# Access Compliance Report

## Public Rights-of-Way

| Intersection ID: 15108 | Main Street: DUNN_AV | Cross Street: HEFLIN_ST | Location: S            |
| ADA ID: 266779E20FA4   | Ramp Type: ParaDiag  | Initial Pass/Fail: Fail | Overall Compliance: No |

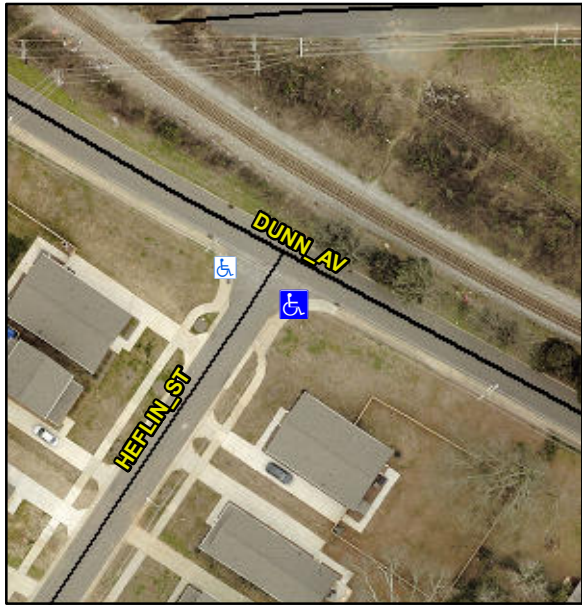
| Codes/Mitigation Info/Possible Solution  |   |            | Field Measurements/Component Compliance |                      |       |            |                             |       |
|--|---|------------|---|----------------------|-------|------------|-----------------------------|-------|
|  |   |            | No                                      | Ramp Width LT (in)   | 45.0  | No         | Ramp Width RT (in)          | 47.0  |
| <b>LT RP &lt; 5%</b>   |   |            | N/A                                     | Gutter Ponding?      | N/A   | N/A        | Gutter Slope (%)            | N/A   |
| <b>R304.5.1</b>  |   |            | N/A                                     | Painted X Walk1?     | No    | N/A        | Painted X Walk2?            | No    |

| Codes/Mitigation Info/Possible Solution  |   |            | Field Measurements/Component Compliance |                      |       |            |                             |       |
|--|---|------------|---|----------------------|-------|------------|-----------------------------|-------|
|  | <b>Remove &amp; Replace Curb Ramp With Two New Directional Ramps or Equivalent.</b> |            | N/A                                     | Ramp Length LT (in)  | 38.0  | N/A        | Ramp Length RT (in)         | 38.0  |
